Memorandum

TO: Columbia River Crossing Task Force
FROM: CRC Pedestrian and Bicycle Advisory Committee (PBAC)
SUBJECT: PBAC Recommendations for World Class Pedestrian and Bicycle Facilities

Columbia River CROSSING

PBAC Proposed Pedestrian and Bicycle System for Replacement Bridge

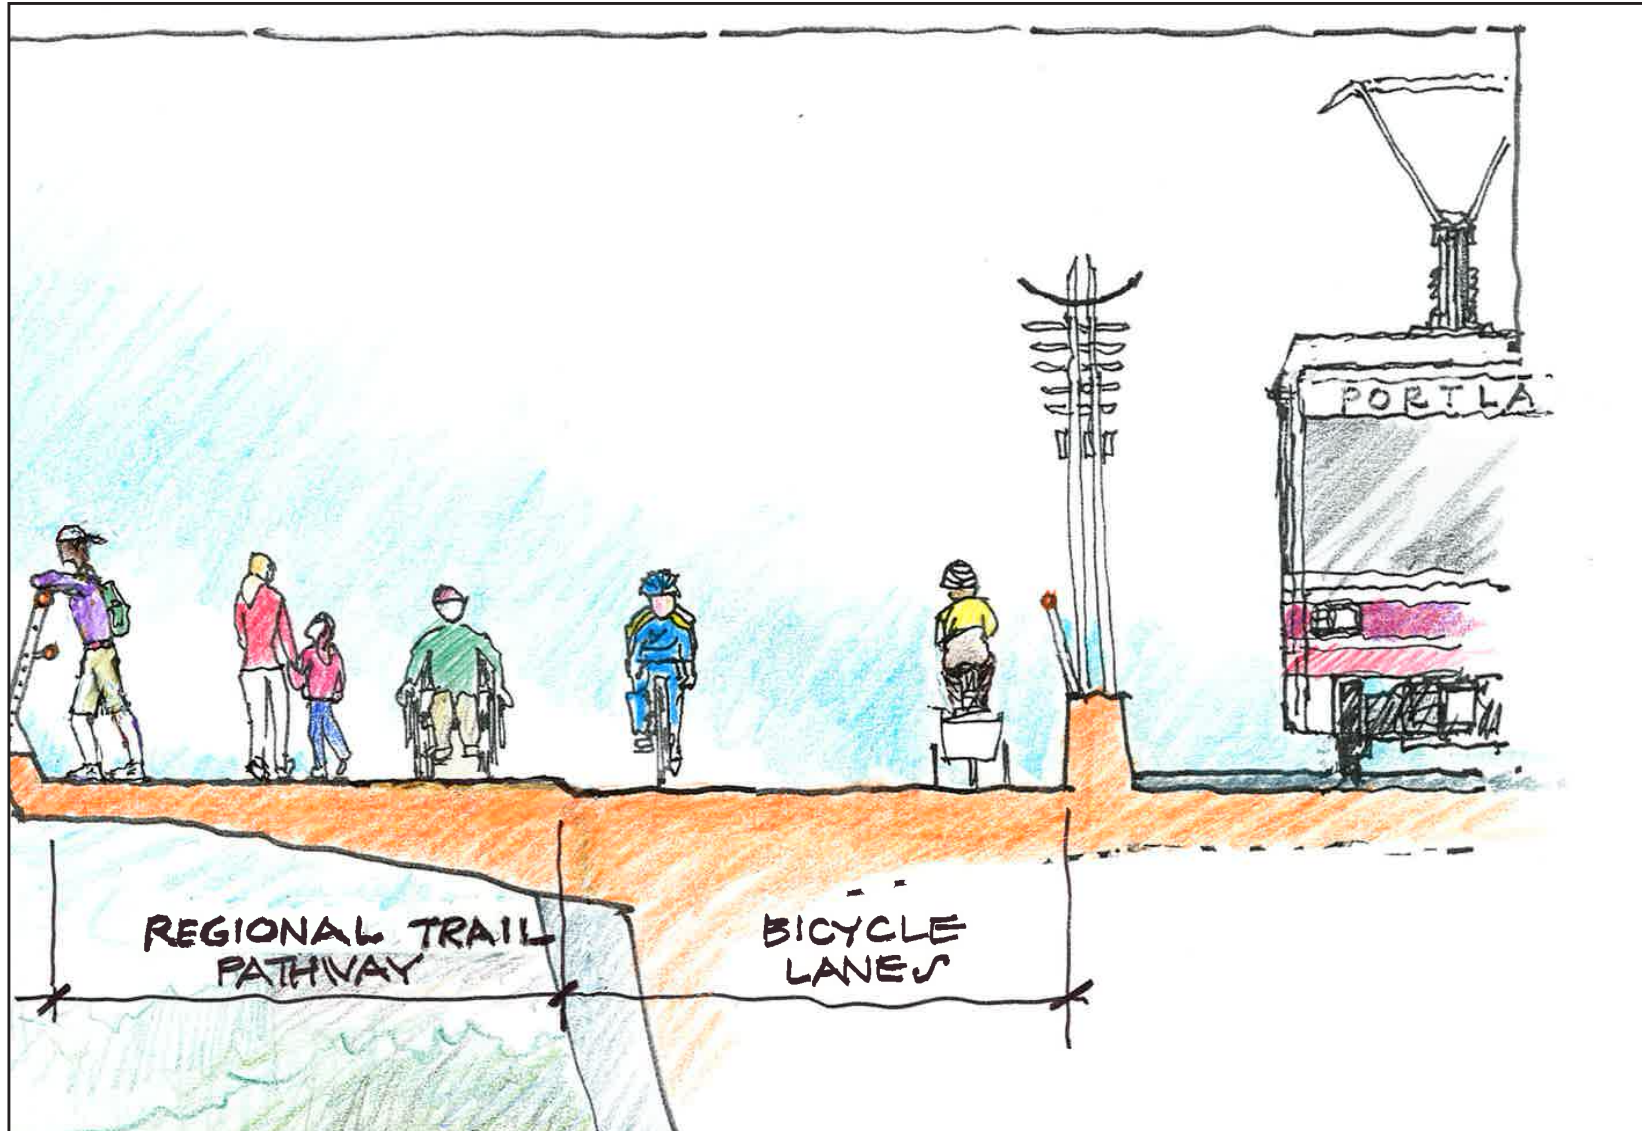
- In addition to the combined regional trail and bicycle lanes on the western bridge, an eight-foot wide sidewalk should be provided on the eastern bridge (the bridge that would serve the northbound traffic lanes) across both the Columbia River and the North Portland Harbor. The sidewalk across the North Portland Harbor would touch down on Hayden Island and use surface street sidewalks to connect to the sidewalk across the Columbia River.

While this facility would primarily serve pedestrians, accommodations should be provided for the occasional recreational bicyclist, e.g., wheel gutters (narrow ramps alongside stairs for rolling a bicycle while climbing stairs). It is understood that for physical and environmental reasons connecting this eastern sidewalk directly with the Vancouver shore would be challenging and most likely would require routing it westerly under the replacement bridge to tie in with the western multi-use pathway above the shore.

- Additional access points, discussed as possibilities in the Draft EIS, should be provided to make the river crossing paths connect more directly to parks and recreational trails. Some examples of these facilities are the Columbia River Waterfront Trail in Vancouver, the river adjacent areas on Hayden Island, and the 40 Mile Loop in Oregon.
- Viewpoints or "belvederes" should be provided at locations along both the regional trail on the western bridge and the sidewalk on the eastern bridge. These features would also function as rest areas for pathway users.

Pedestrian and Bicycle Advisory Committee Recommended Pathway on West Side of West Replacement Bridge (Looking North)

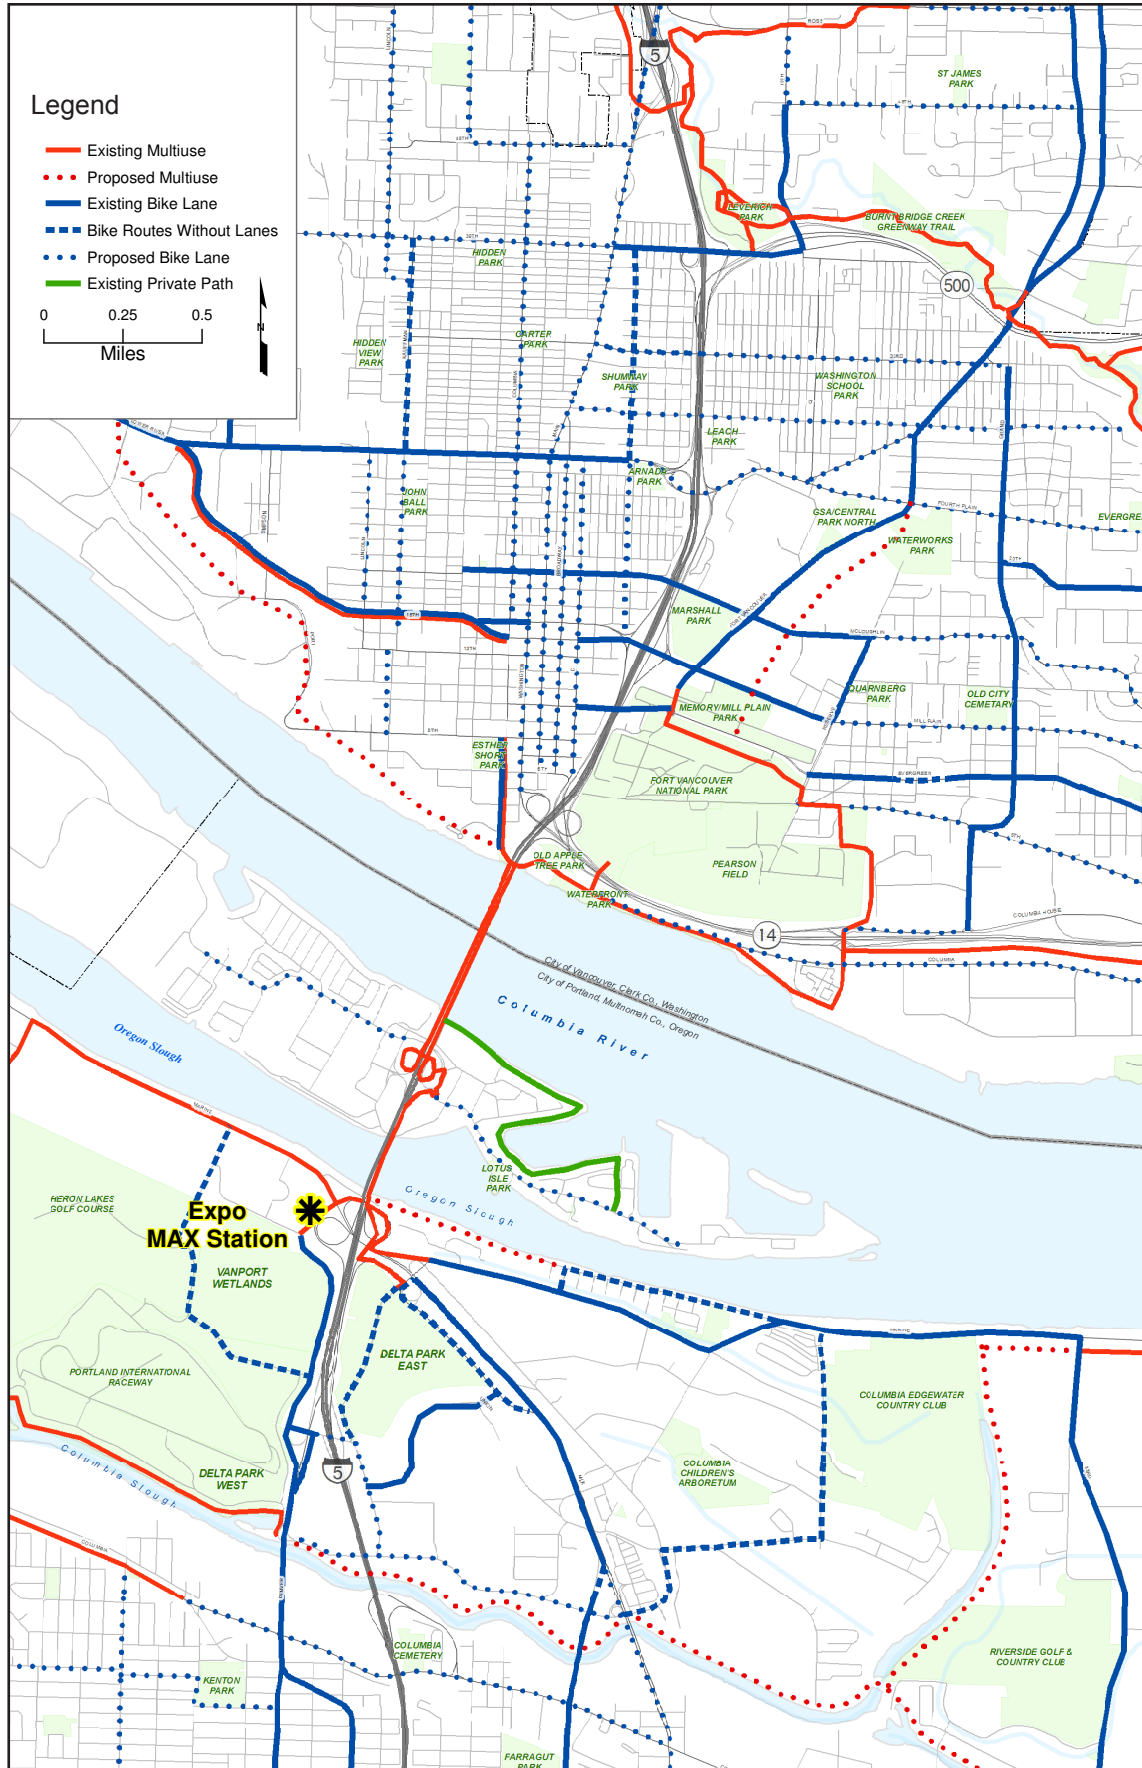
- The overall pathway on the western bridge (adjacent to the transit guideway) must provide separation between recreational users and higher speed bicycle users. To provide this separation, a 12-foot wide regional trail should be provided adjacent to, and to the west of, a pair of six-foot wide bicycle lanes (see attached rendering). These recommended widths are exclusive of potentially needed shy distances, i.e., free and clear of poles and other obstructions to enable safe pedestrian and bicycle movement (a summary of agency standards for multiuse paths, sidewalks and bike lanes is attached).

The regional trail would accommodate pedestrians, persons with disabilities, seniors, families with children, tourists, roller-skaters, and recreational bicycle riders. The adjacent bicycle lanes would be used by bicycle commuters and other faster-moving bicyclists. The regional trail would be at a slightly higher level than the bicycle lanes, but bicyclists in the bicycle lanes would be able to access the trail. Different paving treatments and/or patterns should differentiate the regional trail and the bicycle lanes.
